Access Compliance Report Public Rights-of-Way (Curb Ramps)

Main Street: BRIMHALL_DR Cross Street: SILVER_FOX_RD Location: SE

ADA ID: RPRK211206173802 Ramp Type: Type 1 - Perpendicular Diagonal Initial Pass/Fail: Pass Overall Compliance: No Severity Score: 10

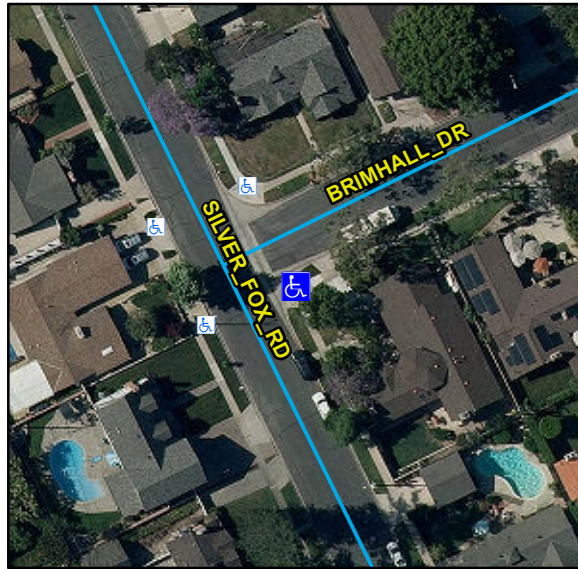
R204.3, R305, STD 1115

Remove & Replace Curb Ramp With Two New Directional Ramps or Equivalent.
